TENNESSEE VALLEY AUTHORITY

JUSTIFICATION OF THE SEISMIC DESIGN CRITERIA USED FOR THE SEQUOYAH, WATTS BAR, AND BELLEFONTE NUCLEAR POWER PLANTS

PHASE II

RESPONSES TO NRC QUESTIONS 1 THROUGH 6

Figure Q1-1

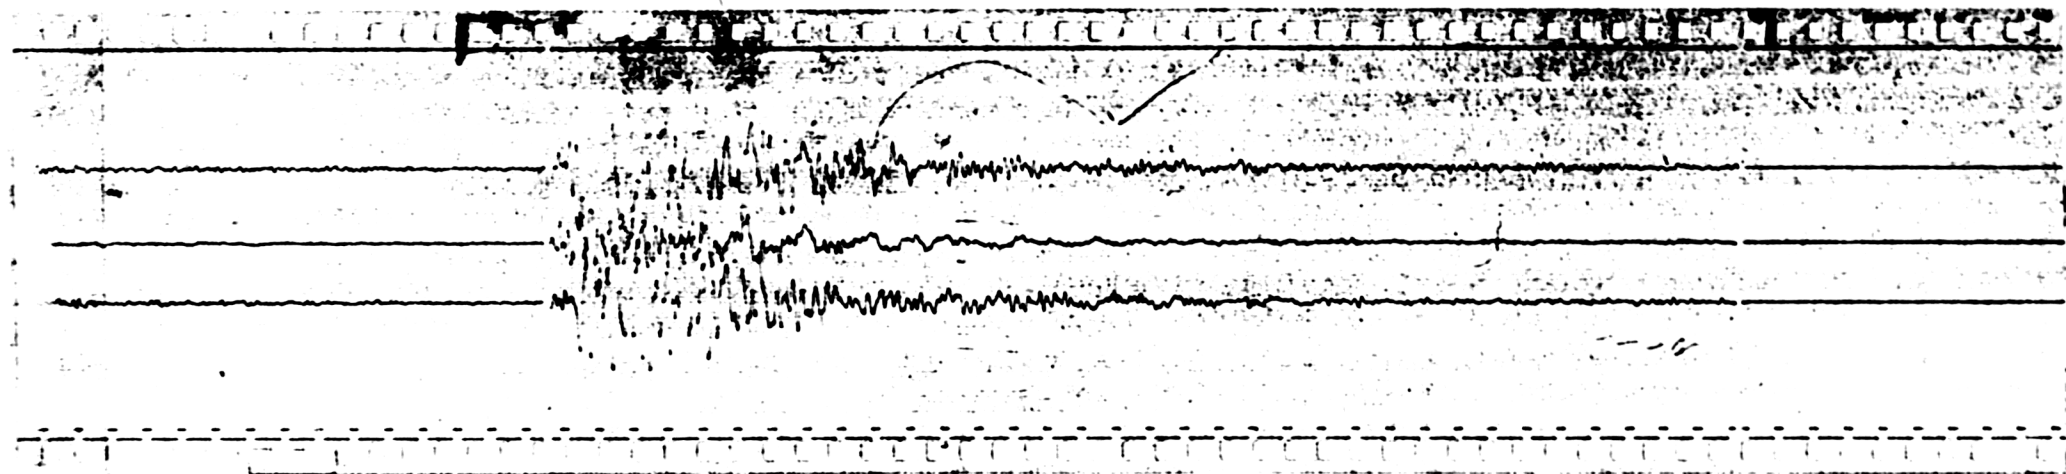
1. The reference (Muzzi and Vallini) used as your source for epicentral data and instrumental locations for the Friuli earthquakes indicates that there were three other sets of strong motion recordings on rock (at Somplago and Tolmezzo) at close distances for the magnitude 6.1 and 6.0 events of September 15, 1976. Figures 37 and 40 of that reference show that while these recordings had "disappeared traces" they also had peak accelerations greater than those recorded at S. Rocco for the same events. Discuss the validity of these measurements and their bearing upon the present study; include any discussions you have had with Muzzi and Vallini regarding this point.

We have discussed these "disappeared traces" with Francesco Muzzi. He indicated (ref. Q1-2) the following. Apparently the light traces at the high accelerations became so thin they could not be read. He also indicated Tolmezzo is a peculiar site with a complicated geologic structure and considerable fissured rock. It should not be interpreted as a rock site because more recent measurements show very low shear wave velocities.

Muzzi also sent copies of the five "disappeared traces." These traces, although of poor quality, are shown in figures Q1-1 through Q1-5. He has learned recently of a successful attempt by colleagues [Franco Capozza, CNEV (ref. Q1-4)] of the JCS [Joint Study Commission] to reconstruct the traces (ref. Q1-3). We understand this should be completed in 1979.

FIGURE Q2-2

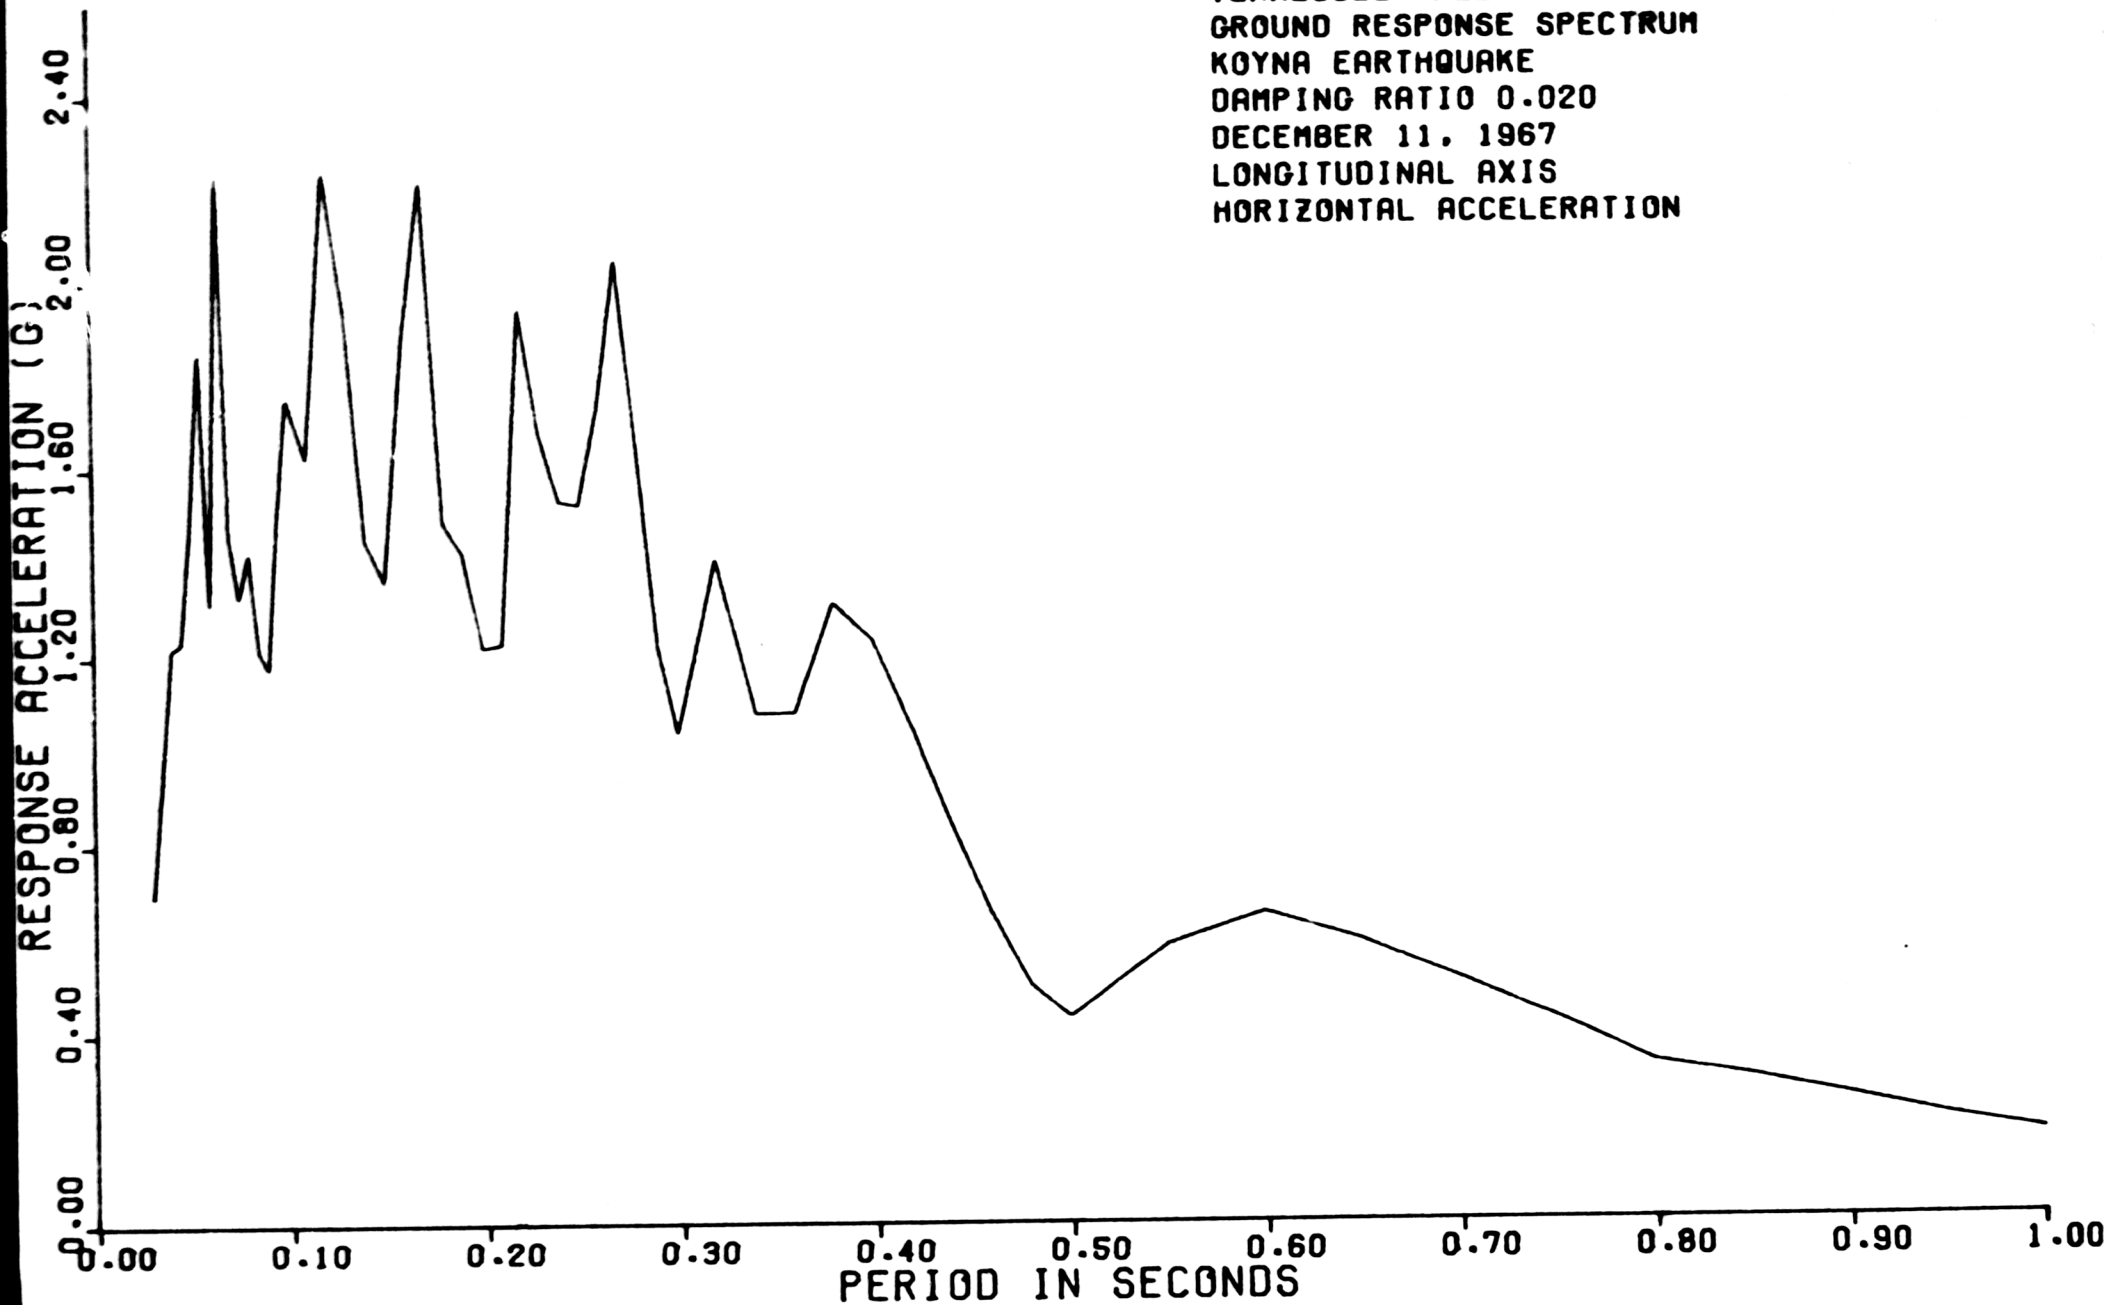
2. The Earthquake Evaluation Study of the Auburn Dam Area (Woodward-Clyde, 1977) utilizes the Koyna Dam records of the magnitude 6.0 (mb) Koyna event of December 11, 1967, in estimating nearby motion at rock sites. Although the recordings were made at about mid-height on the dam, investigators (Chopra and Chakrabarti, 1973; Guha and others 1971) have apparently judged that they represent the free-field motion at the site. The U.S. Geological Survey in their review of Auburn Dam study has also taken this assumption to be valid. Discuss these records and those of associated events at Koyna and their bearing on the present study.

Figures Q2-1 and Q2-2 show the response spectra for 2 percent damping in the transverse and longitudinal directions of the dam. Figure Q2-1, for the transverse direction, shows a very predominant peak at a natural period of about 0.12 second which suggests strong amplification of ground motion. Another interesting observation about the response spectra in the transverse direction is the peaks at about 0.09 and 0.06 second. Chopra and Chakrabarti (ref. Q2-2) performed a finite element analysis of the nonoverflow monolith and determined natural periods of 0.326, 0.122, 0.093, and 0.063 second in the transverse direction. The analysis showed the higher modes (particularly the second mode) providing significant response as evidenced by figure Q2-3 which shows the calculated acceleration (using the recorded motion as input). Figure Q2-3 shows significant amplification at midheight caused by the higher modes. The higher modes (0.12, 0.09, and 0.06 seconds) are shown in the response spectra which indicate amplification due to the structure. Since the recording was made at midheight and the second mode was predominant for this location, the first mode (0.33 second) would not be amplified significantly. This is also reflected in the response spectra for the transverse direction. No analyses have been made in the longitudinal direction of

the dam. The response spectra in the longitudinal direction are not typical of other observed rock spectra or of any observed ground motions. Since the instrument was located in a monolith near the right bank (ref. Q2-2), it is possible that the abutments and topography affected the longitudinal motion.

Based on the above, it is concluded that the Koyna recordings have been influenced by the dam and probably by the abutments and topography around the abutments. Therefore, it is not representative of a free-field top of rock response spectra and should not be included in the data set.

FIG. Q3-1

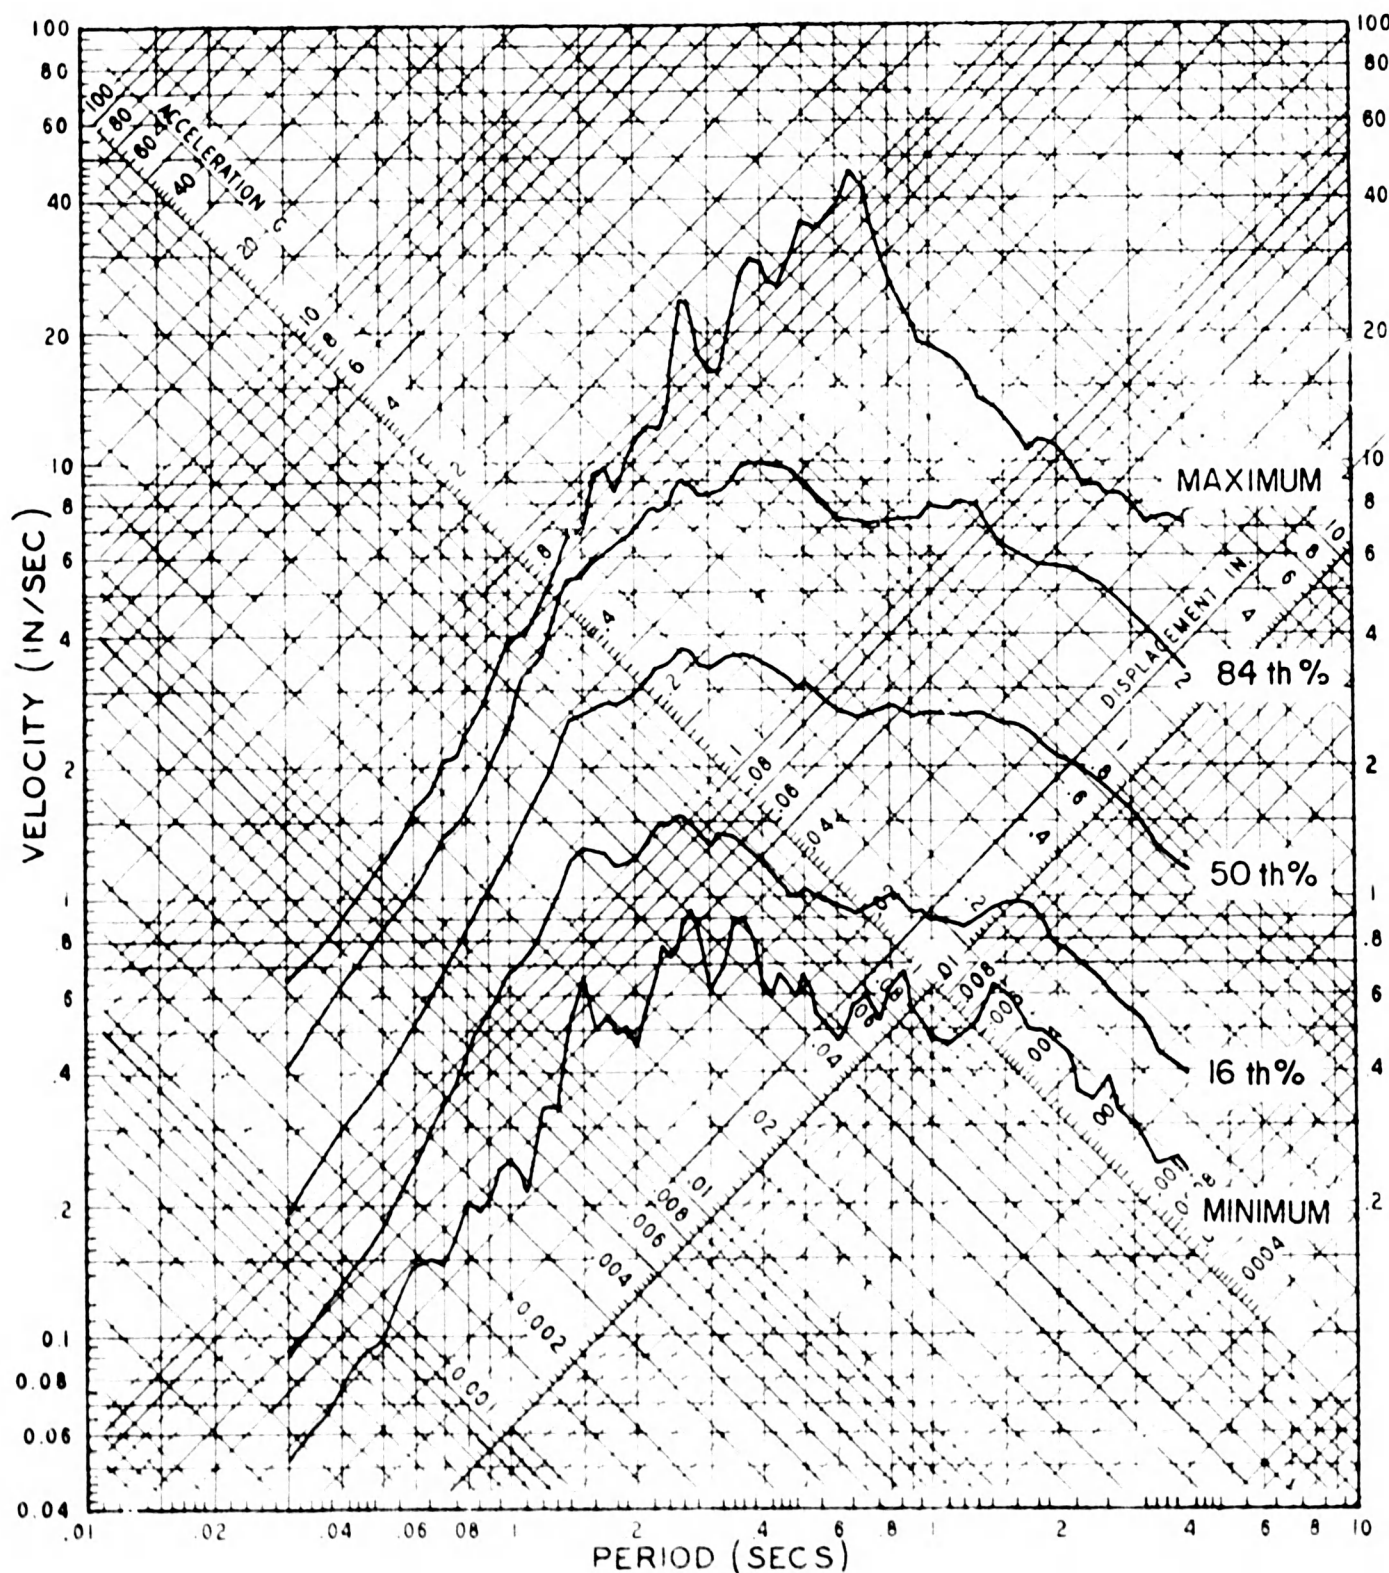
3. Determine whether the distribution of response spectral values at each frequency for the available data is better fit by a normal or lognormal distribution. Calculate 50th and 84th percentile spectra for the appropriate distribution.
4. Determine to what percentile different frequency bands of the design spectra correspond to with respect to the distribution calculated in 3. Discuss the significance of each such frequency band to the engineering analysis of structural components.

Figures Q3-1 and Q3-2 represent the statistical distribution of the data when they are assumed to be lognormally distributed. These figures show the maximum, minimum, 16th, 50th, and 84th percentile response spectra for all 13 records for 4 and 7 percent damping, respectively.
